Access Compliance Report

Public Rights-of-Way

Intersection ID: 30214	Main Street: HIDDEN_CREEK_DR	Cross Street: MOSS_STREAM_LN	Location: SW
ADA ID: 7999AB82C3B4	Ramp Type: PerpDiag	Initial Pass/Fail: Pass	Overall Compliance: No
		Severity Score: 17.5

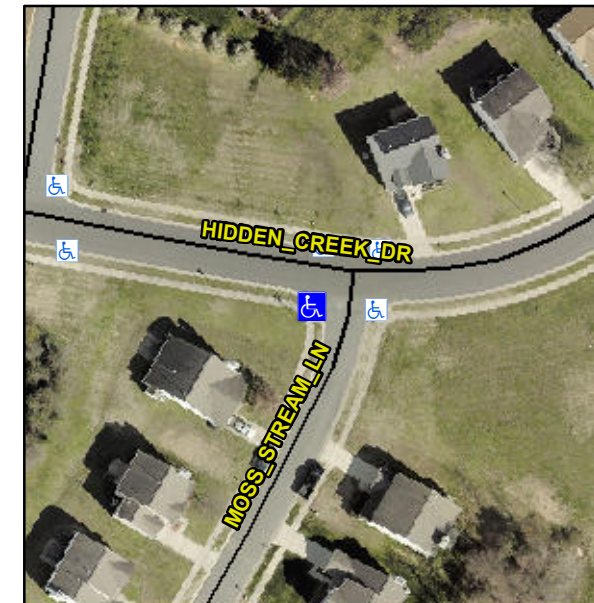
Not Found, R304.2.1, R304.2.2-Perp, R304.3.2-Para, R304.5.3, R305, R302.7.2

Compliance	Description	Data	Compliance	Description	Data
N/A	Ramp Length (in)	47.0	Yes	Ramp Slope (%)	5.8
Yes	Ramp Width (in)	51.0	Yes	Ramp XSlope (%)	1.7
N/A	Flare Type LT	Sloped	N/A	Flare Type RT	N/A
N/A	Flare Slope LT (%)	0.1	N/A	Flare Slope RT (%)	7.2
N/A	Flare Traversable LT?	No	N/A	Flare Traversable RT?	No
No	Landing Length (in)	47.0	No	DWS Provided?	No
Yes	Landing Width (in)	97.0	N/A	DWS Contrast?	No
No	Landing Slope (%)	3.7	N/A	DWS Length (in)	N/A
No	Landing X Slope (%)	5.1	N/A	DWS Full Width?	No
N/A	Landing Curb? (Y/N)	No	N/A	DWS Offset (in)	N/A
N/A	Shared Landing?	No			
Yes	Gutter Ponding?	No	Yes	Gutter Slope (%)	3.8
No	Gutter Lip Ht (in)	0.5	No	Gutter X Slope (%)	2.5
N/A	Painted X Walk1?	No	N/A	Painted X Walk2?	No
	X Walk 1 Direction	To E		X Walk 2 Direction	To N
N/A	X Walk 1 Width (in)	N/A	N/A	X Walk 2 Width (in)	N/A
	X Walk 1 Slope (%)	1.2		X Walk 2 Slope (%)	5.8
	X Walk 1 X Slope (%)	0.9		X Walk 2 X Slope (%)	1.5

Remove & Replace Curb Ramp With Two New Directional Ramps or Equivalent. Remove & Replace Gutter.
